Technical Bulletin

Model: AT-C1 Booklet Finisher (SR3000) Date		:e: 15-Jun∙	-09	No.: RB793002		
Subject: SR3000 Jam		Prepare	d by: M.	Kumagai		
From: 2nd Tech Support Sec. Service Support Dept.						
Classification:	☐ Troubleshooting	Part inf	orma	tion	Action	n required
	Mechanical	Electric	al		Servic	ce manual revision
	Paper path	Transm	it/rec	eive	Retro	fit information
	Product Safety	Other ()	🛛 Tier 2

Model: AT-C1 Booklet Finisher (SR3000)

Model: AT-C1 Booklet Finisher (SR3000) Date					-10	No.: RB793003
Subject: Parts information					d by: M.	Kumagai
From: 1st Overseas Tech Support Sec., 1st PQM Dept.						
Classification:	Troubleshooting	Part inf	orma	tion	Action	n required
	Mechanical	Electric	al		Servic	ce manual revision
Paper path Transmit/r			it/rec	eive	Retro	fit information
	Product Safety	Other ()	Tier 2

Photo 1 IMPORTANT: Only move the shaft back and forth. Do not rotate.

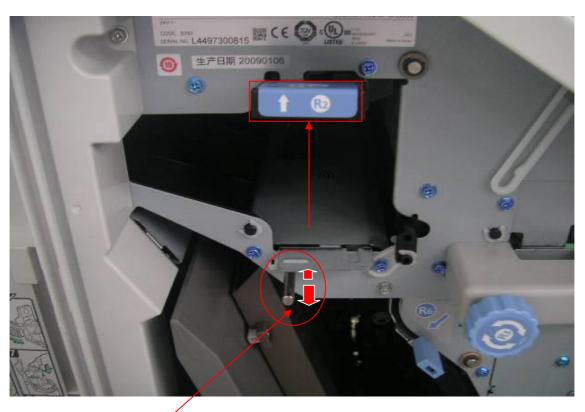
- 1. Open the front cover of the finisher.
- 2. Pull up the "R2" shift guide.
- 3. Move the shift roller shaft (circled in red) back and forth slowly. **Do not** turn the shaft. **Note:** This will cause the shift motor (**B7935817**) to rotate.

Photo 2

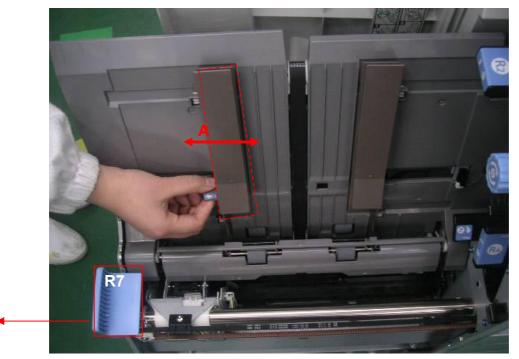
- 4. Pull out the stapler unit using the "R7" guide.
- 5. Move the operator-side jogger fence back and forth slowly three times within the range of movement shown by arrow "A".

Note: This will cause the first B7935815 motor ("Motor 1" in Photo 5) to rotate.

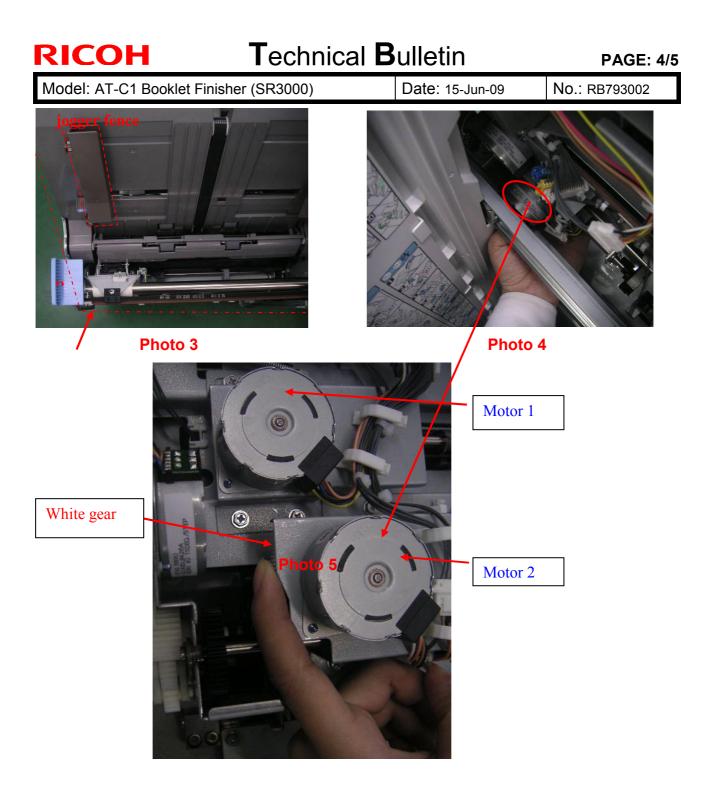
- 6. Confirm the following (See Photo 3):
 - The stapler unit is pulled out as far as it can go
 - The operator-side jogger fence is at its front-most position
- Turn the white gear in Photo 5 clockwise 360 degrees.
 Important: Reach under the rail to access the gear (see Photo 4).
 Note: This will cause the second B7935815 motor ("Motor 2" in Photo 5) to rotate.

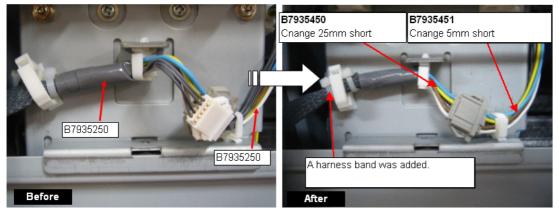
Change / Reason: The lengths of the following harnesses were changed to prevent connectors contacting the main frame.

Old parts number	New parts number	Description	Q'ty	Int	Page	Index
B7935250	B7935450	HARNESS:STAPLER	1	X/O	23	24
B7935251	B7935451	HARNESS:CONNECTIN G:STAPLER	1	As a Set	23	23

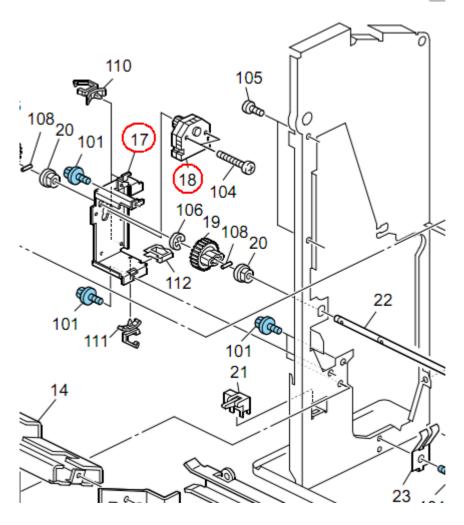
Old part	New part	Description	Q'ty	Int	Page	Index	Note
number	number						
AX040214	AX040248	DC Motor Bracket	1	X/O	30	17	*
B7933111	B7933112	DC Motor: Shift: Upper	1	O/X	30	17	*
		Lower: Drives

These parts have been affected on this cut-in serial #: L4408301002

*These parts should be replaced as a set.
